DESIGN/DEVELOPMENT REVIEW COMMISSION  
**DESIGN REVIEW DISTRICT**  
**REGULAR AGENDA**  
EVALUATION SHEET  
Case # 1

**PROJECT NUMBER:** DDRC-2026-0013

**ADDRESS:** 700, 760, 770, 780 Gervais Street

**NATURE OF REQUEST:** Request Certificate of Design Approval for new construction.

**A** VISTA DEVELOPMENT PEDESTRIAN PLAZA AND HOTEL ENTRANCES DETAIL  
NOT TO SCALE

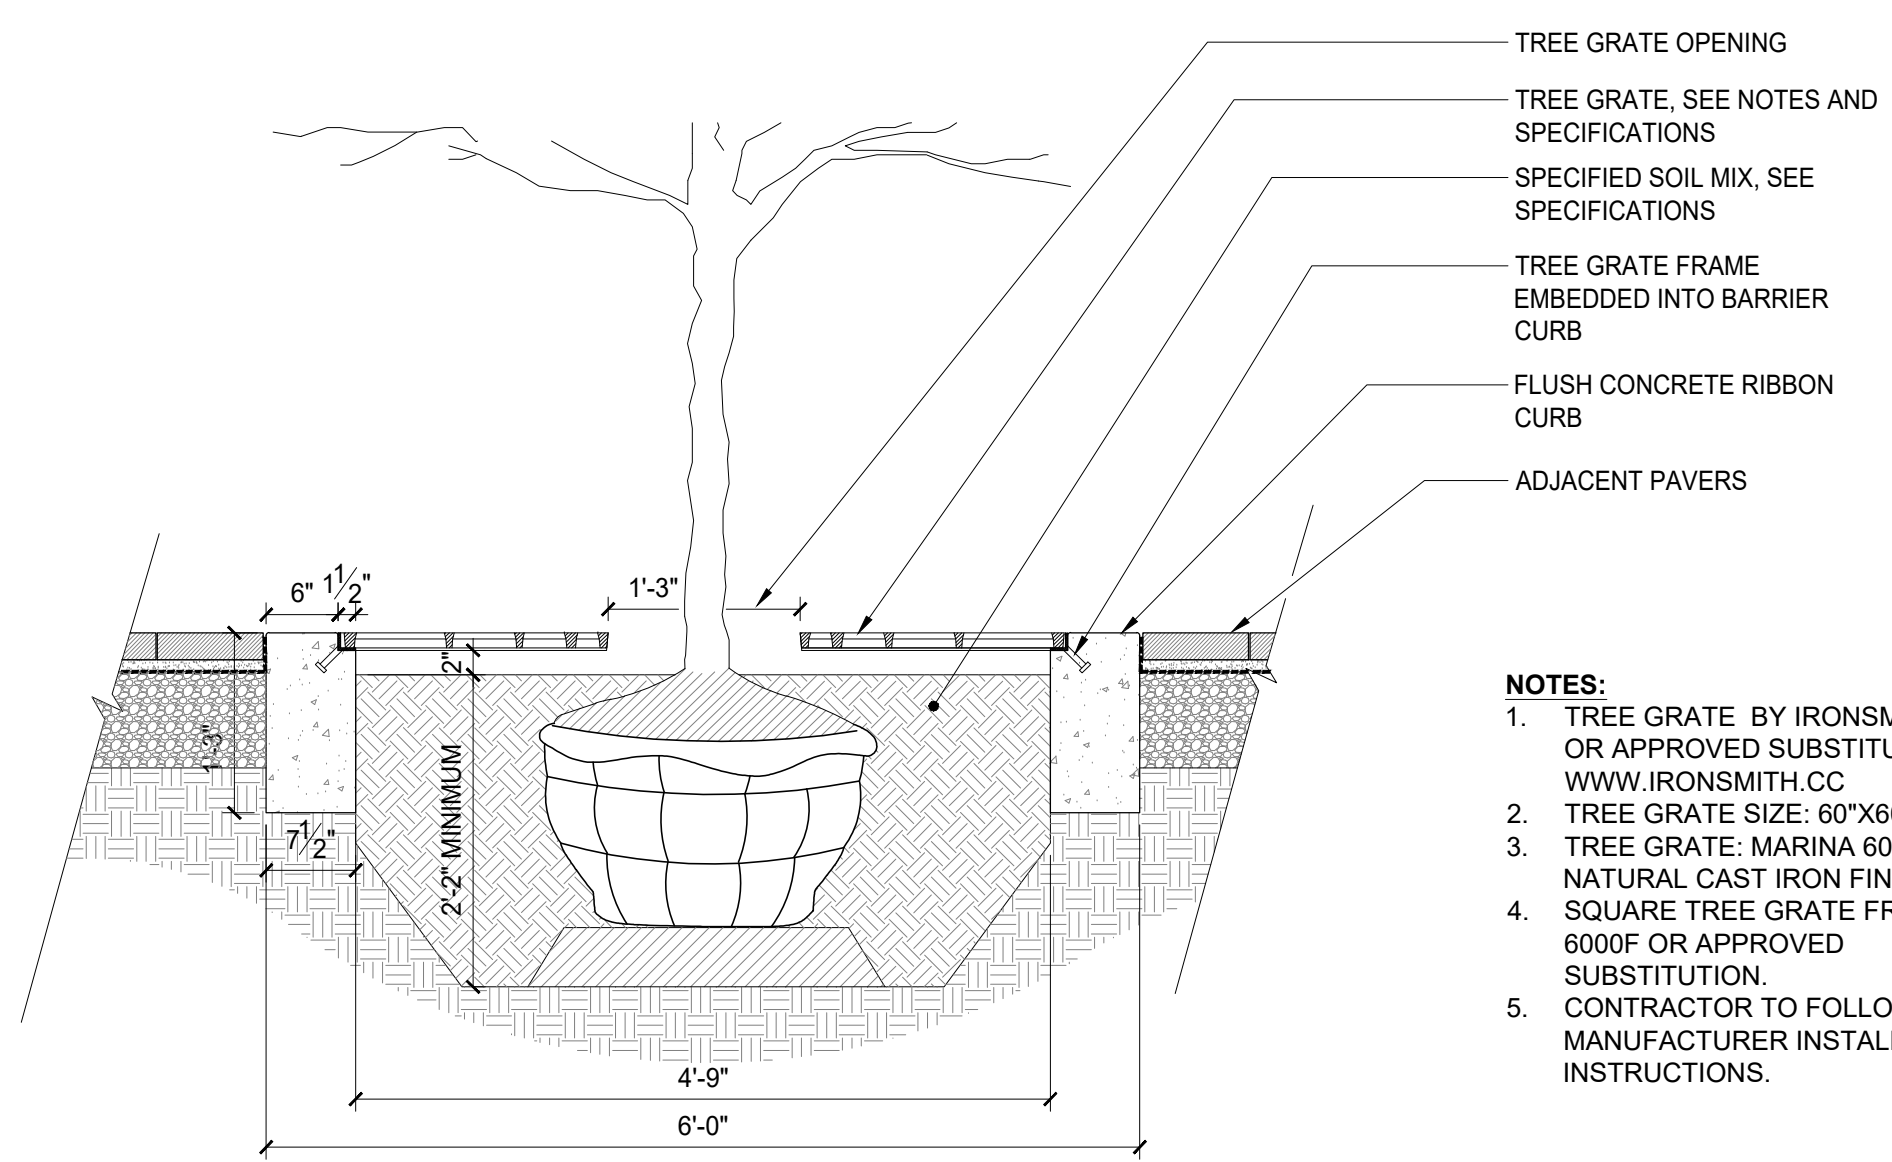
The apartment's two semi-public courtyards are activated by balconies which overlook the courtyard space. A pedestrian plaza immediately adjacent to the Hyatt Centric hotel entrance intercepts pedestrians coming into the site from the pedestrian promenade off of Gervais Street. This plaza features multiple brick paving patterns, plant beds and bike racks. It is flanked by a circular raised plant bed and flagpole structure that is centered between the two Hyatt hotel entrances.

Staff finds that additional outdoor seating and either a piece of public art or a water feature is needed within these open spaces.

- Provide a pathway connecting the Wayne Street sidewalk to the site’s interior pedestrian pathways;
- Include additional outdoor seating and either a piece of public art or water feature within the site’s interior open spaces;

**SITE RETAINING WALL  
ELEVATION**

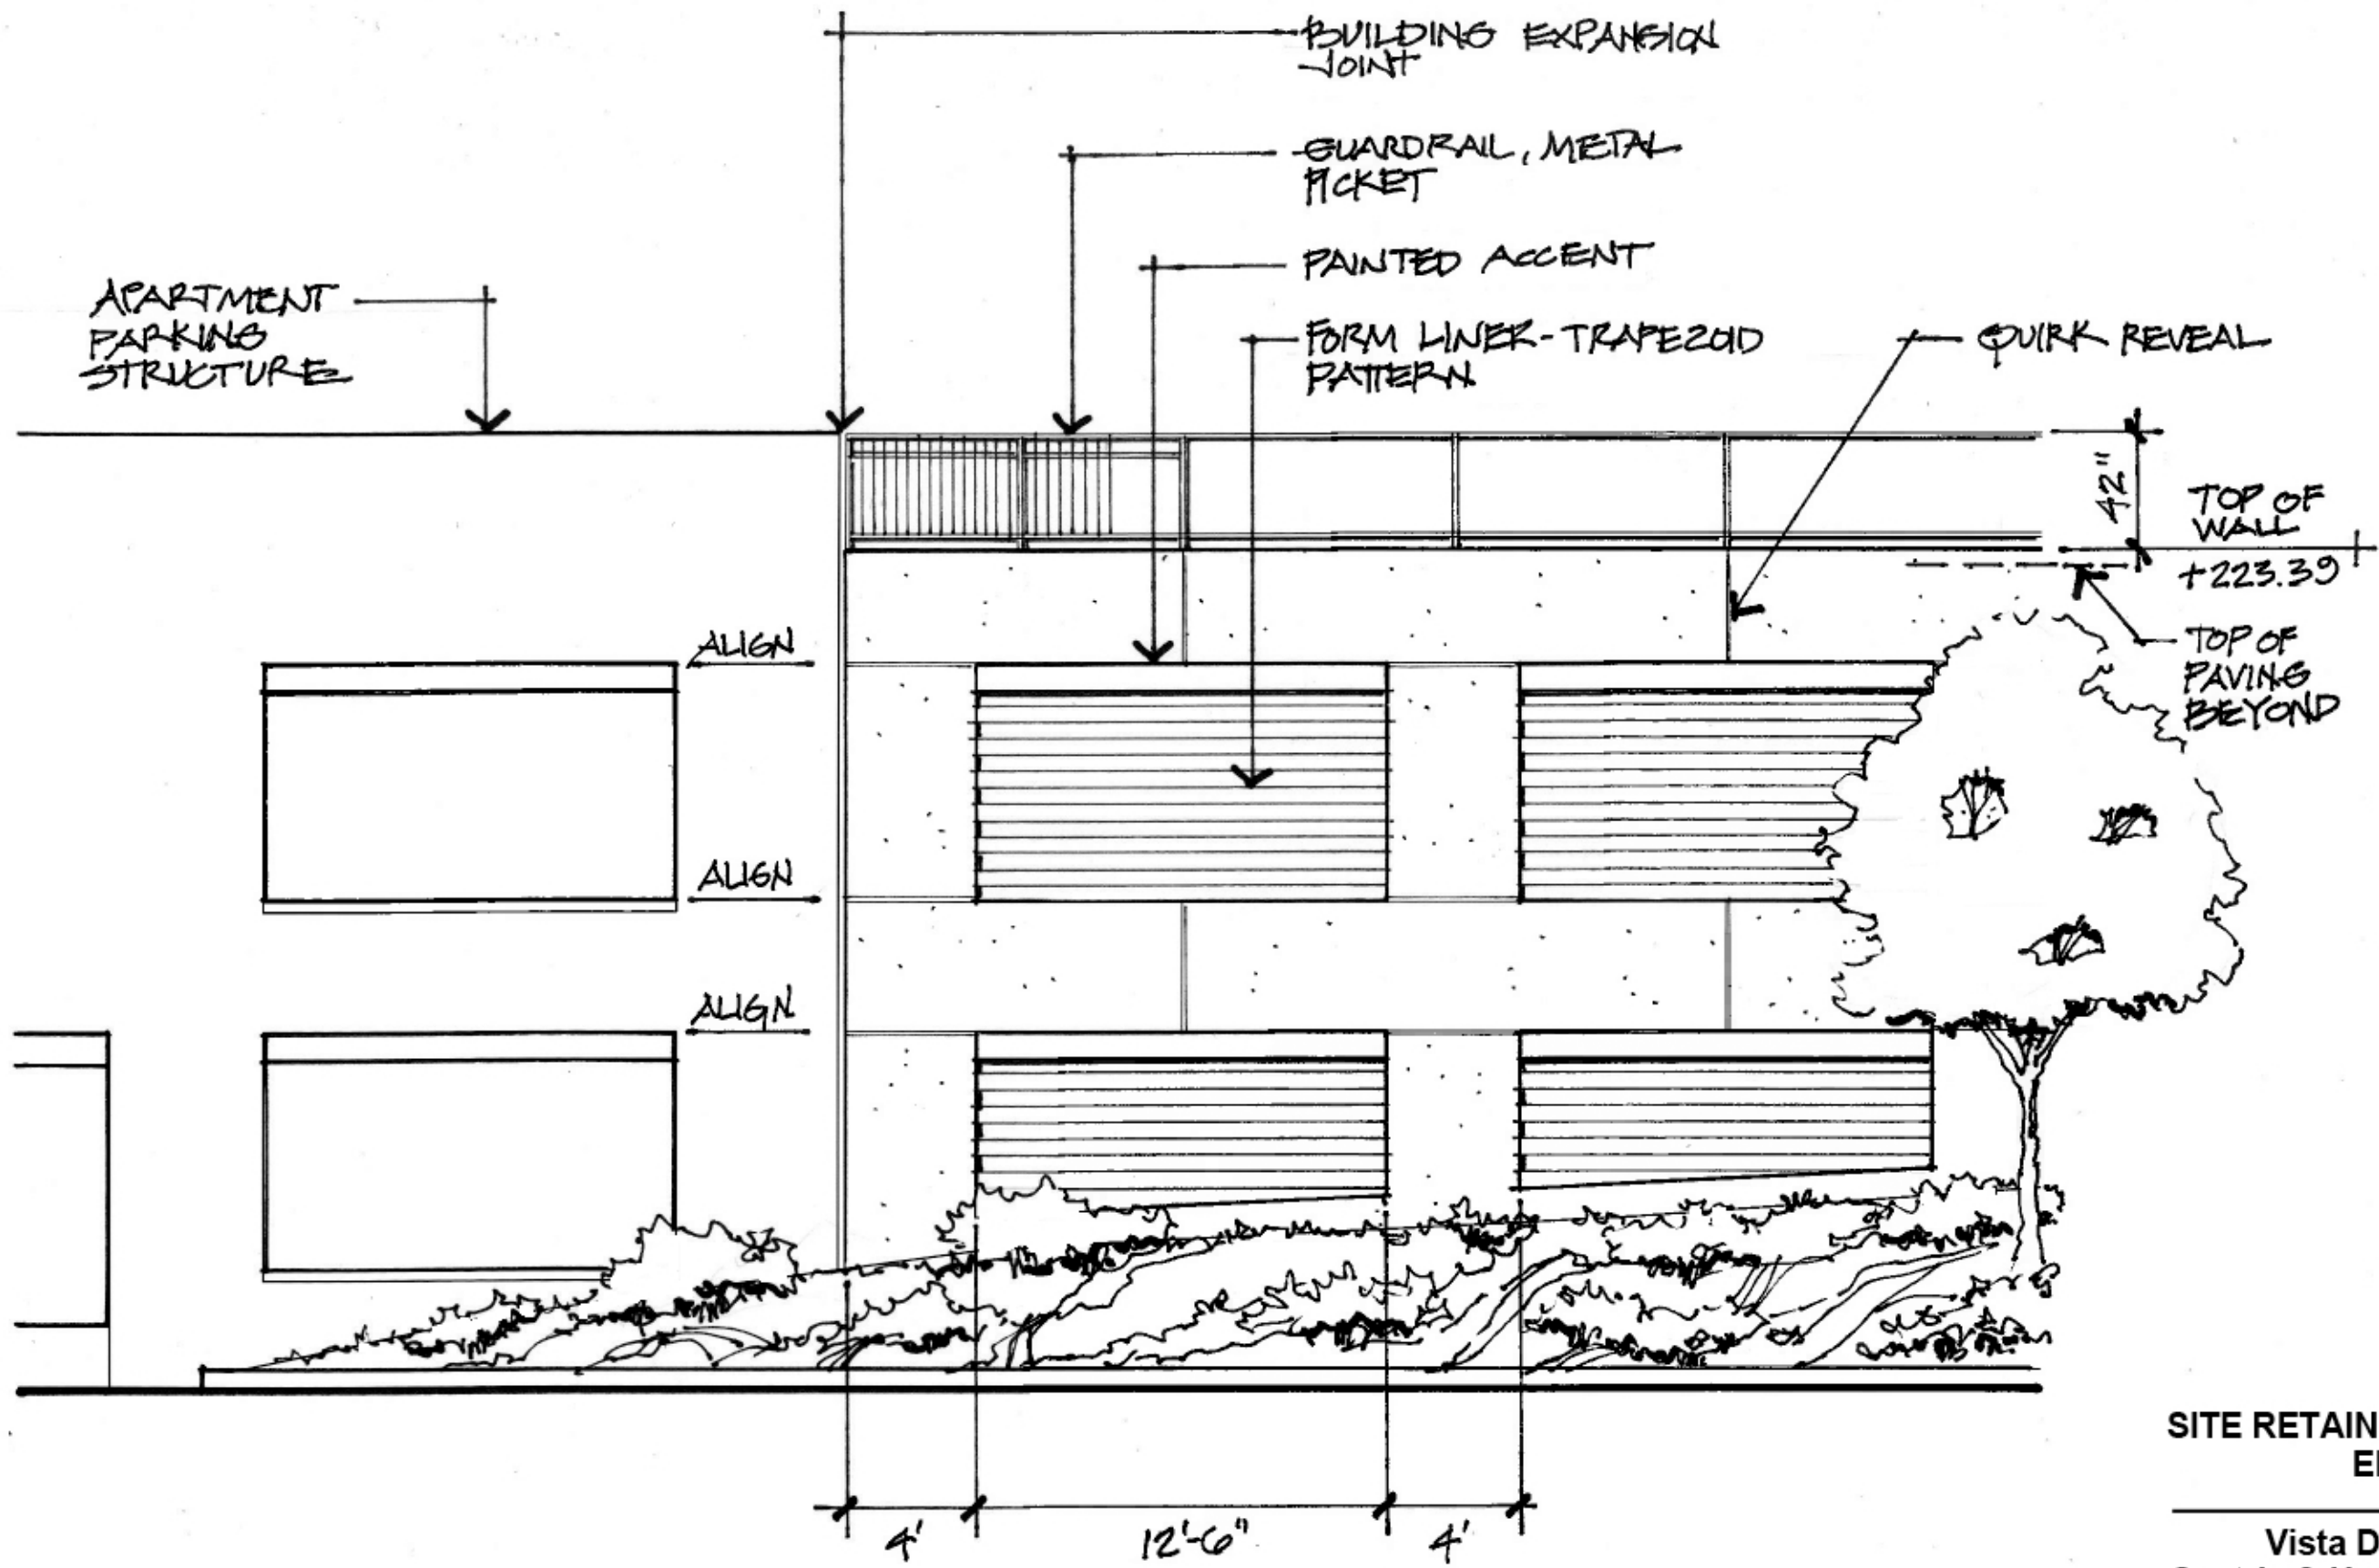
The most significant grade change on the site is along Pendleton, where the garage takes advantage of the change with an entrance to the lower level. The primary pedestrian route provides a pedestrian stair to traverse from the rear of the hotel site down to Pendleton. There is a less dramatic grade change along Wayne Street but should incorporate a sidewalk even if some type of retaining wall is needed.
